PLANNING RESPONSES
SUNLIGHT HOUSE
OCTOBER 2024

GROUND FLOOR CAFE GLAZING

CDN/24/0714 & CDN/24/0713

This document forms a response to CDN/24/0714 (Condition 7) and CDN/24/0713 (Condition 11). Some areas of this glazing had to be revisited and redesigned in line with the Fire requirements and to support the latest reception layout and cafe testfits.

SOUTH LIFT LOBBY PARTITION STRATEGY

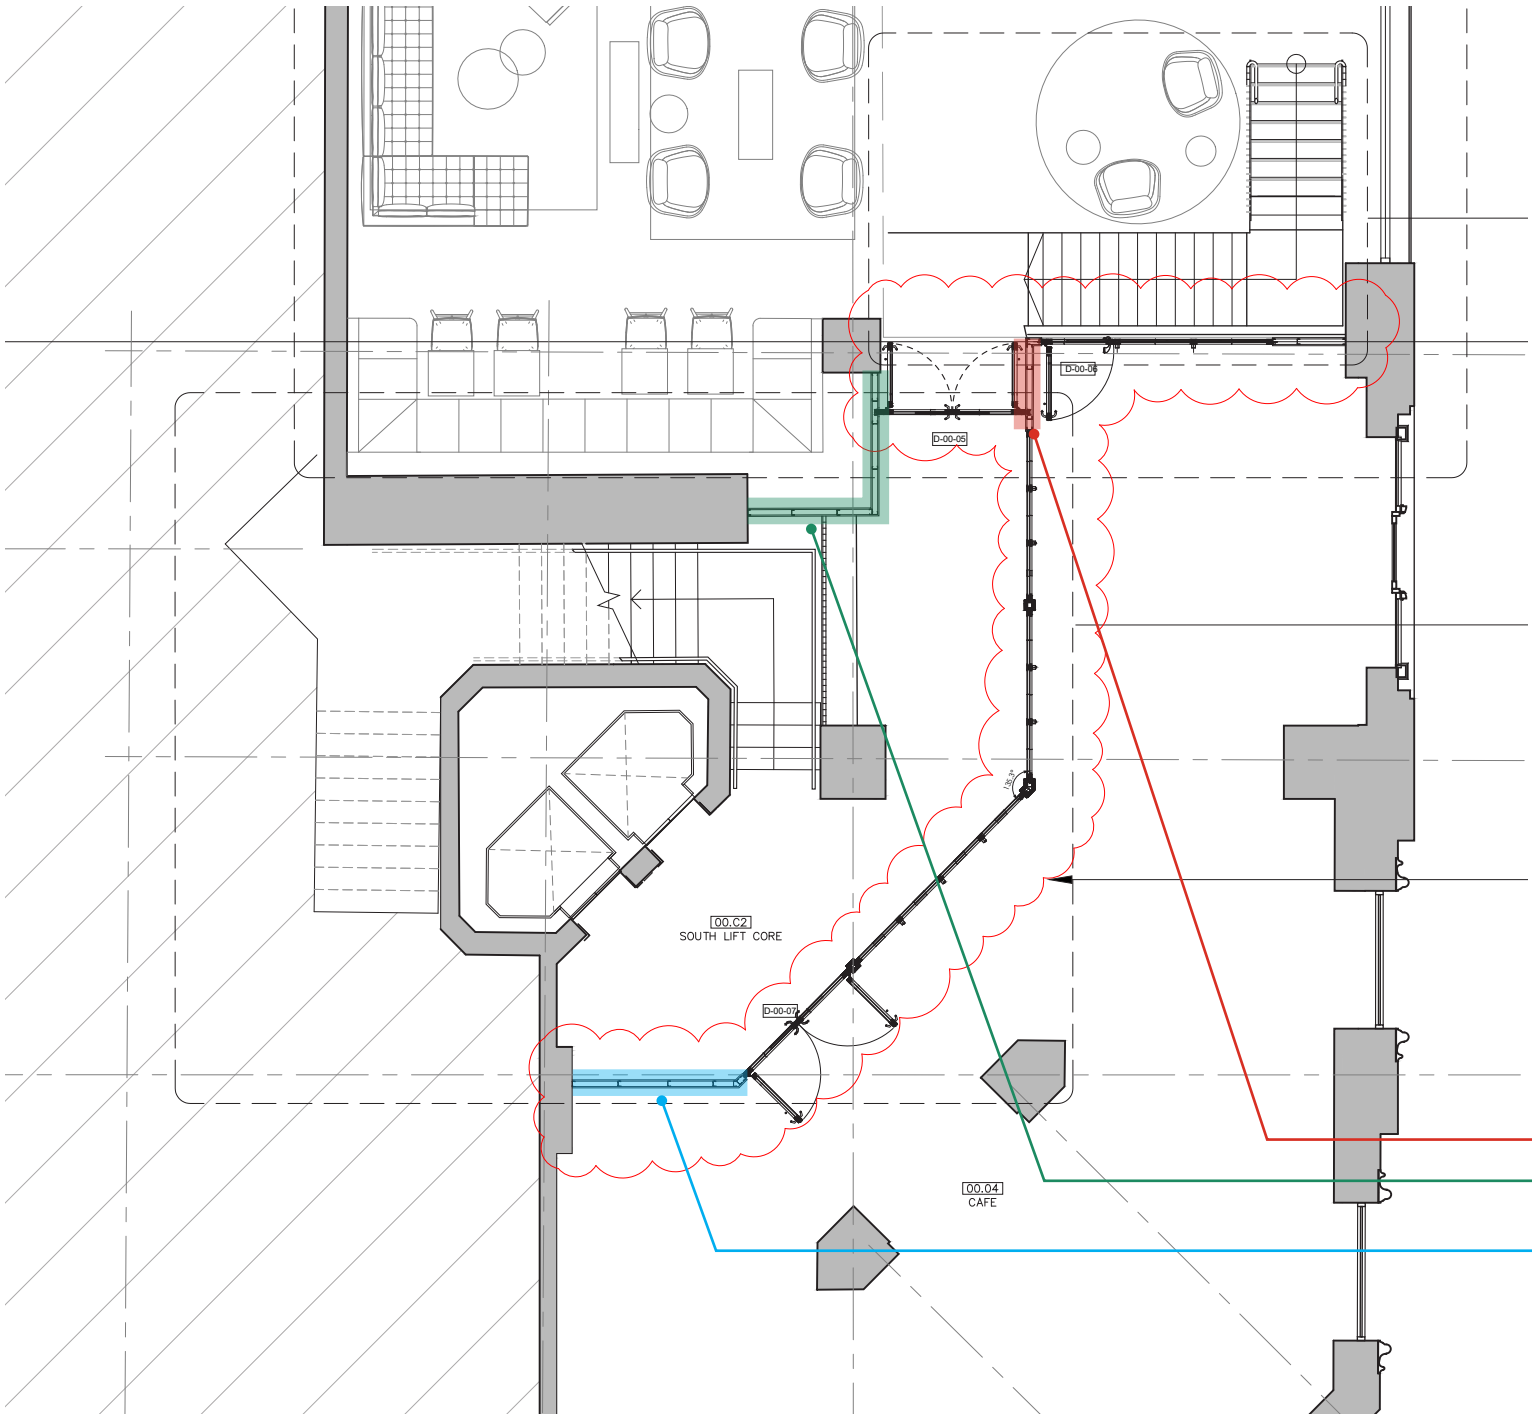
The glazing scope within the south lift lobby has been reduced and replaced with plasterboard partitions in the highlighted areas following ongoing discussions.

- Partition introduced to provide the 60min FR fire compartmentation line. Following paged explain the proposal for additional glazing in this area.
- Plasterboard partition is more suitable to supporting proposed services running through this area.
- This location will likely back onto a proposed cafe storage or WC unit (see testfits for details), therefore glazing will need to be removed and replaced with plasterboard to ensure security/privacy.

POTENTIAL LAYOUTS

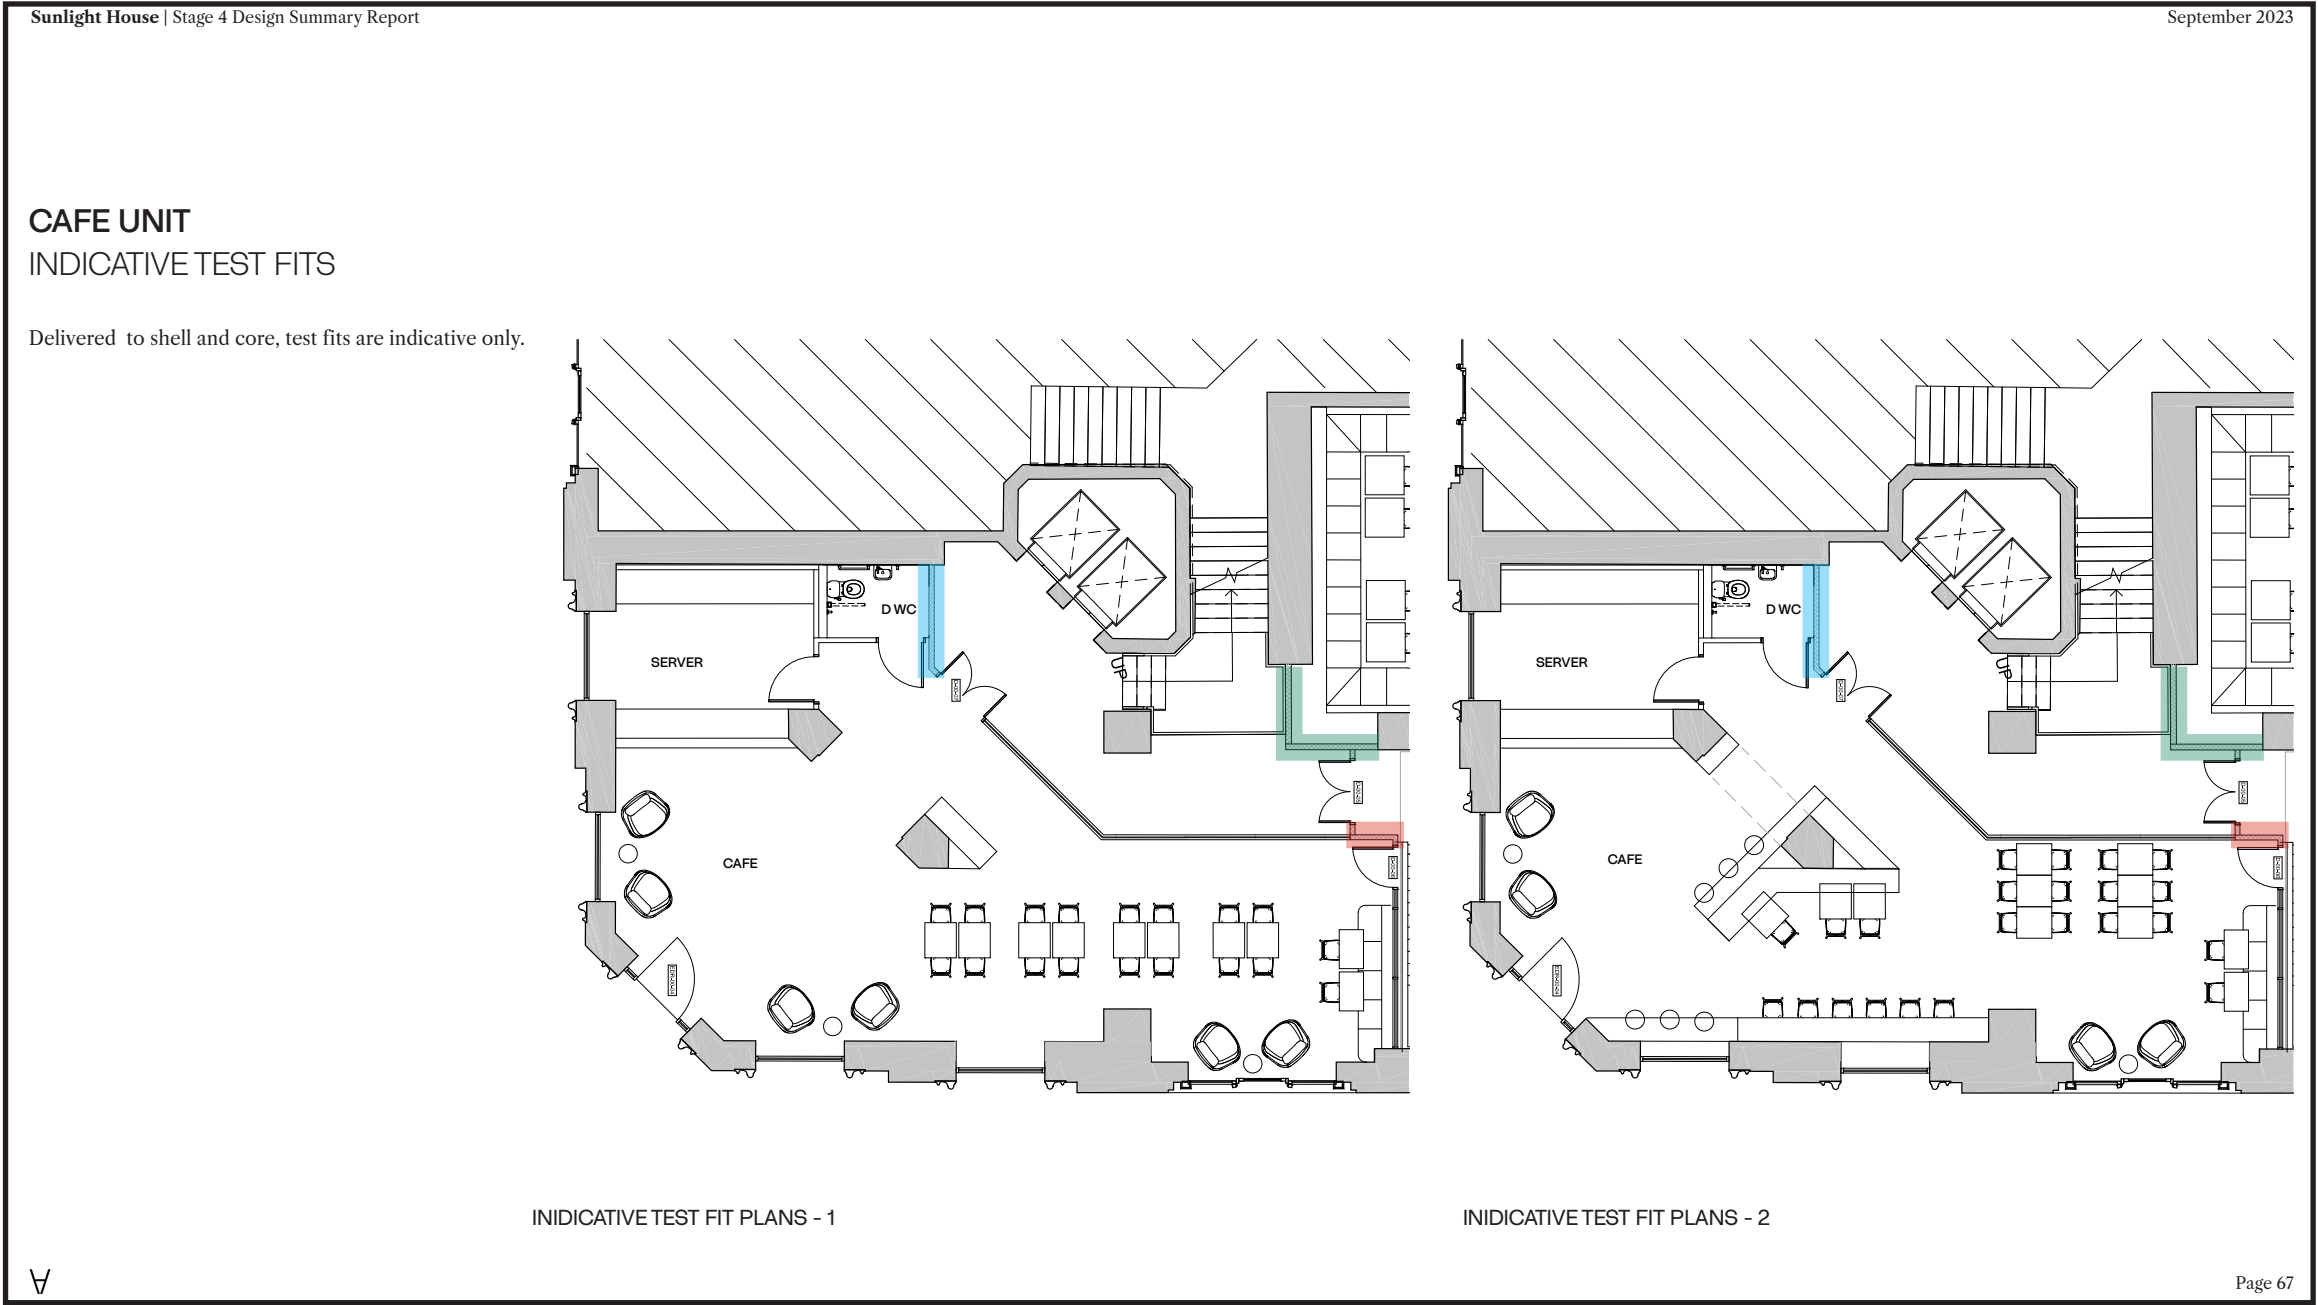
The removal of the highlighted glazing partitions will ensure that the scheme will align to the cafe testfits shown.

- Plasterboard partition is more suitable to supporting proposed services running through this area.
- This location will likely back onto a proposed cafe storage or WC unit (see testfits for details), therefore glazing will need to be removed and replaced with plasterboard to ensure security/privacy.

PROPOSED NEW GLAZED OPENING

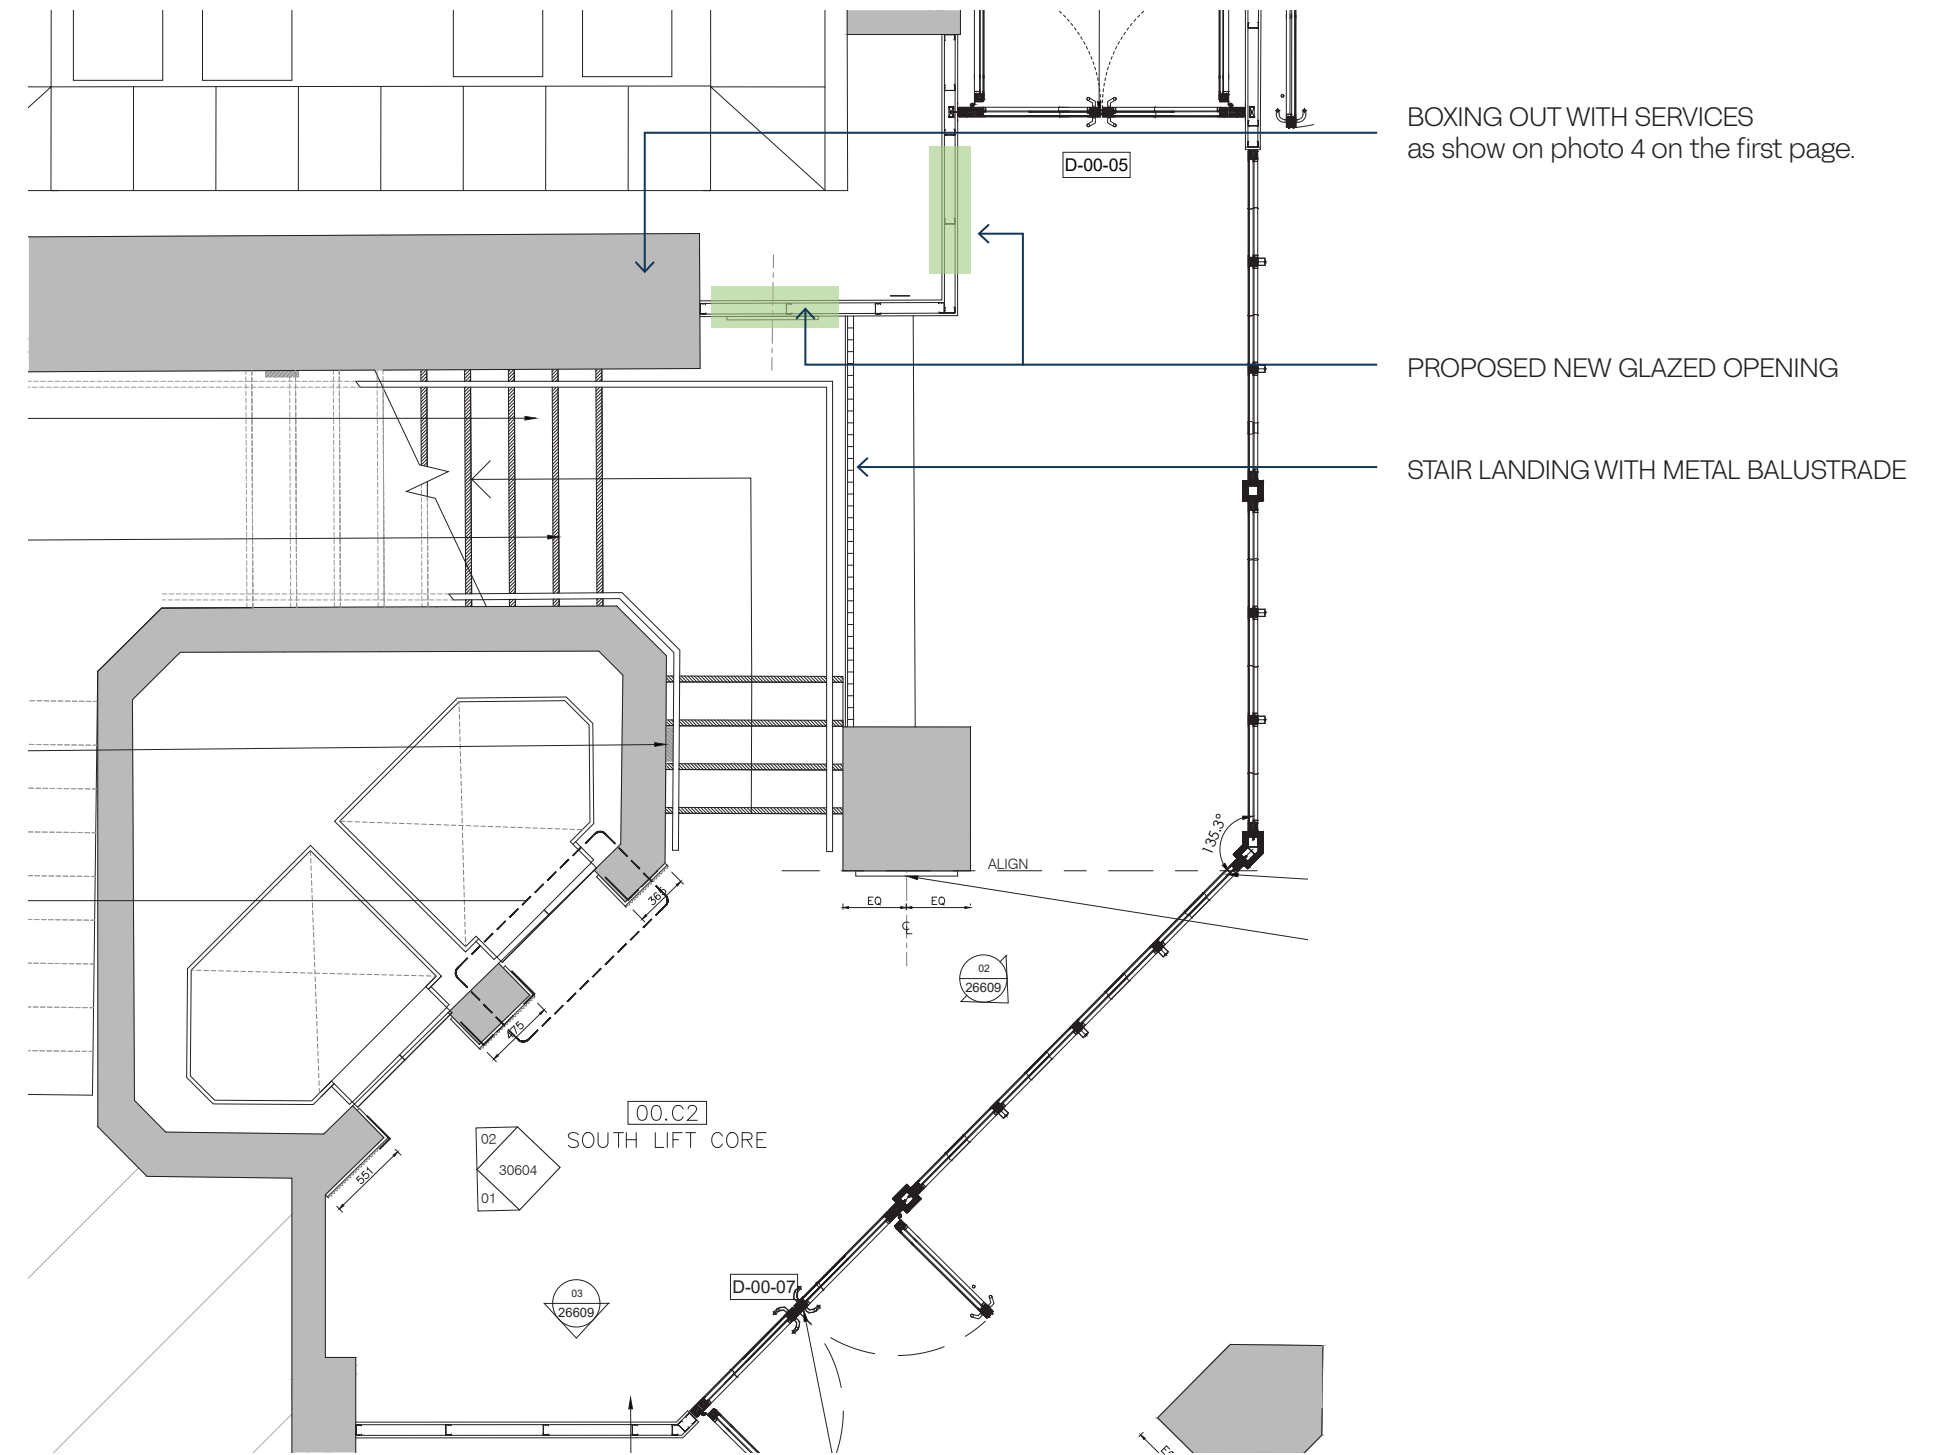
Following feedback from 24th of October additional glazed screen between the South Core staircase and reception is proposed in two locations as shown.

Maximum opening given the constraints of the steel beam, stair landing with protective metal balustrade and services routed within the boxing out and high level.
